## WORCESTER COUNTY BID ADDENDUM

Replacement of Overhead Doors at Worcester County Roads Building

Addendum 1 –

Prebid Meeting Notes of 2/13/17 meeting and Clarifications

PROJECT: <b>DETAILS</b>	
DATE: 09/19/2018	SCALE: AS NOTED
DRAWN BY: <b>S1</b>

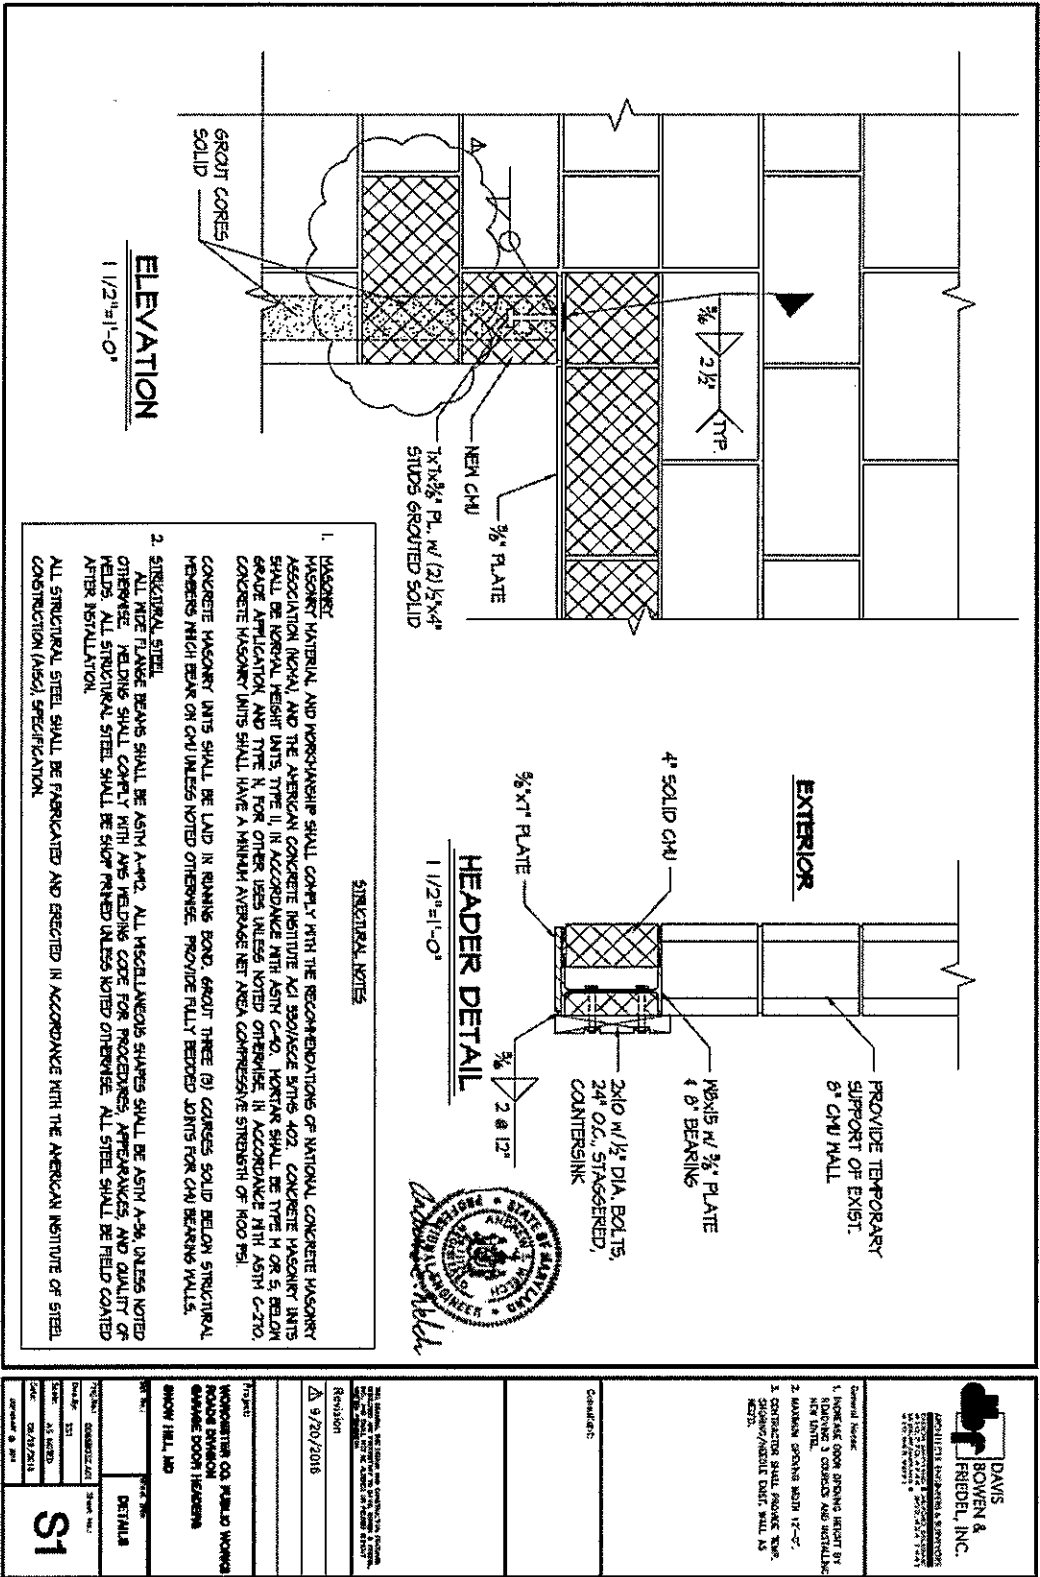
13. Door wind design is required to be 123 mph.
14. Lentil Questions
  - a. Are angle shapes allowed instead of the I-beam? No, the bids should include the steel I-beam as per the design drawing.

- b. Can the bolt spacing be increased at the I-beam? Yes but will require engineers review and approval based on torsion spring attachment.
  - c. Can the lentil beam be centered? Yes. Use cut block to fill each side flush to the wall above.

- d. I-beam lengths shall be determined by the contractor for each opening.
15. Contractors shall verify before any demolition all dimensions and door sizes including but not limited to opening clearances and hardware mounting details. Any conflicts must be provided in writing to the County for resolution prior to the start of demolition.
